UNITED STATES PATENT AND TRADEMARK OFFICE

APPLICATION NO.	FILING DATE	FIRST NAMED INVENTOR	ATTORNEY DOCKET NO.	CONFIRMATION NO.		
09/681,674	05/18/2001	Yoshifumi Natsuyama	JP920000096US1	3666		
877	7590 05/16/2003					
IBM CORPORATION, T.J. WATSON RESEARCH CENTER			EXAMINER			
	P.O. BOX 218 YORKTOWN HEIGHTS, NY 10598			RUDE, TIMOTHY L		
			ART UNIT	PAPER NUMBER		
		2871	·

DETAILED ACTION

Figure 11

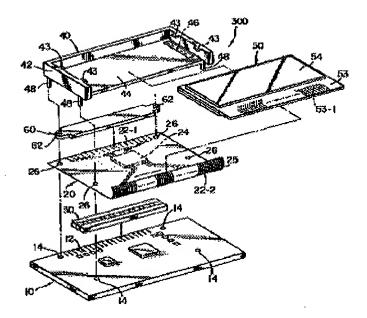
As to claim 4, Muramatsu discloses in his third embodiment, Figures 11 and 12, (col. 10 line 66 through col. 13, line 6) a liquid crystal display device, 50, comprising: a pair of glass substrates facing each other, each having electrodes for applying voltage to a liquid crystal material on a facing surface (typical); a circuit board, 10, for supplying said voltage; and a liquid crystal driver tape carrier package, 20, (col. 11, lines 7-9 and col. 7, lines 1-3) for connecting said electrodes of said glass substrates to said circuit board and mounting a liquid crystal driver chip (col. 11, lines 7-9 and col. 7, lines 4-13), wherein said liquid crystal driver tape carrier package and said circuit board anchor holes, 26 and 14, and anchor pins, 48, are inserted into said anchor holes, whereby said liquid crystal tape carrier package is fixed to said circuit board (col. 11, lines 45-48).

Muramatsu does not explicitly disclose a display wherein said liquid crystal driver tape carrier package is soldered to said circuit board via said pins.

As to claim 5, Muramatsu discloses the liquid crystal display device further comprising a light guide, 44 (Applicant's frame), for allowing said anchor pins to stand on a surface holding said pair of glass substrates, wherein said liquid crystal driver tape carrier package and said circuit board are fixed to said frame.

As to claim 6, Muramatsu discloses the liquid crystal display device wherein a pair of said anchor holes, 26, is located with said liquid crystal driver chip, 24, between (diagonally per Figure 11).
